**Commonwealth Edison**

Subject: Byron Station Unit 1  
Inservice Inspection Program  
NRC Docket No. 50-454

Reference: April 11, 1989, letter from L. N. Olshan to  
H. E. Bliss

RELIEF REQUEST NR-12

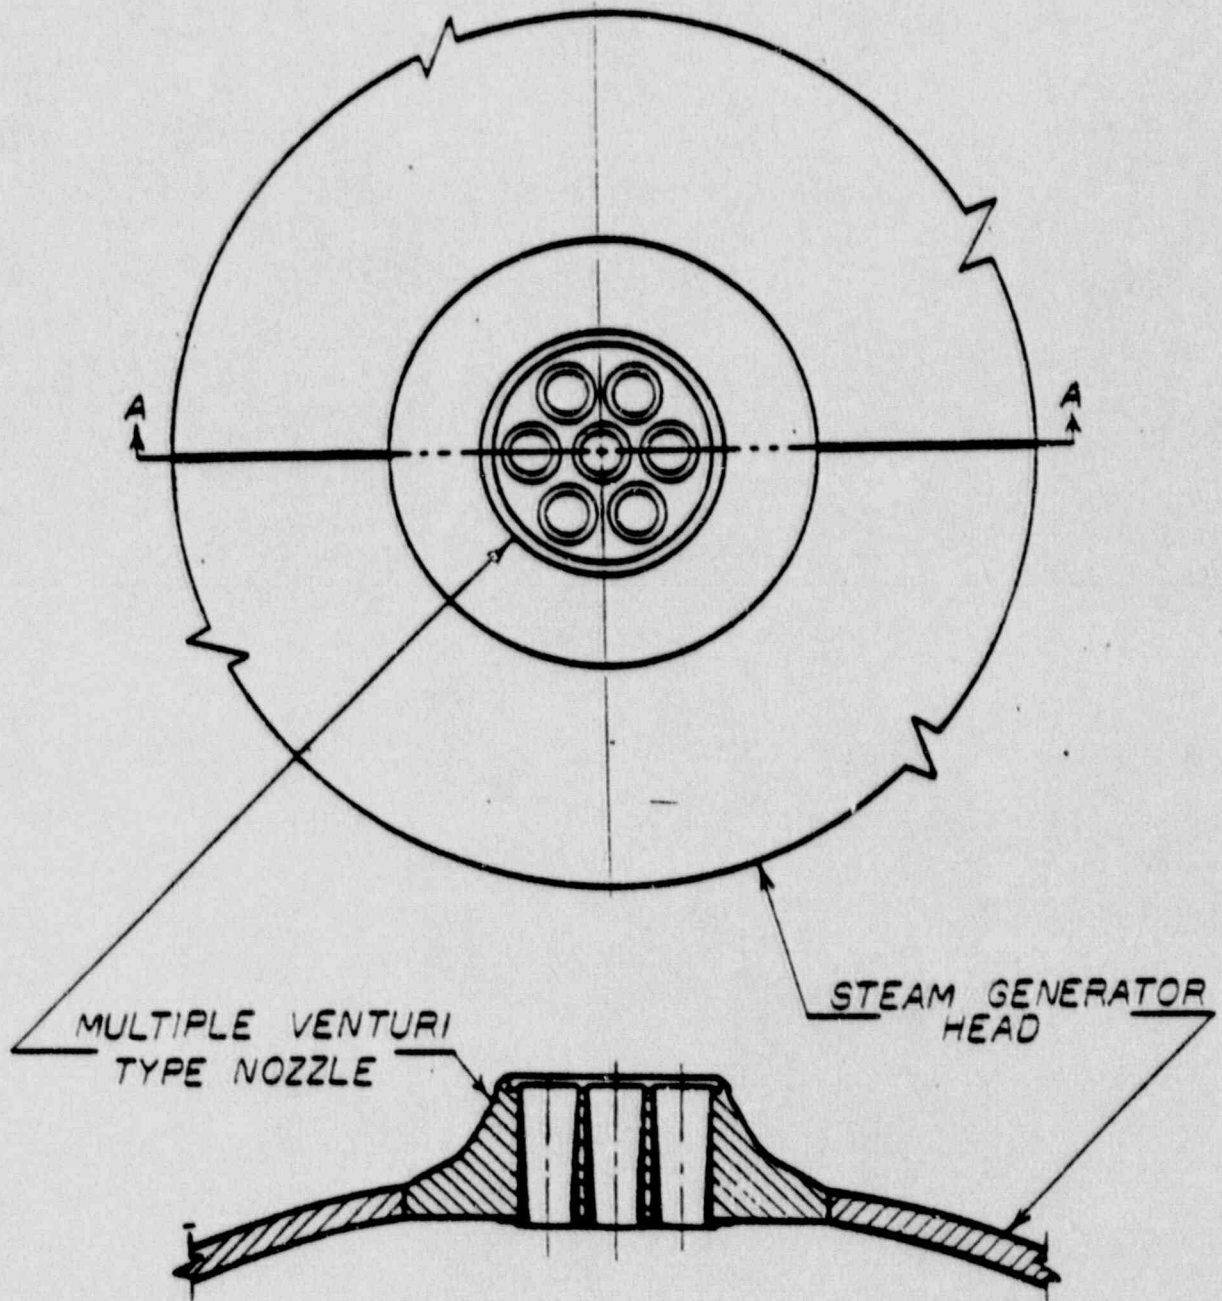
Insufficient justification for the Residual Heat Removal heat exchanger nozzle inner radii in Relief Request NR-12.

The revised Relief Request NR-12 is contained in Attachment B. The attachment includes a picture of the reinforcement pad obstruction welded on the nozzle inner radii. The reinforcement pad makes ultrasonic examination of the inner radii impossible. Commonwealth Edison requests that the NRC review the updated information and grant Relief Request NR-12.

<u>Component Number</u>	<u>Item Number</u>	<u>Attachment Numbers</u>
1RC-01-BA	SGN-02, SGN-03	1 & 2
2RC-01-BA	SGN-02, SGN-03	3
1RH-02-AB	RHDN-01, RHDN-02	1 & 2
2RH-02-AB	RHDN-01, RHDN-02	3
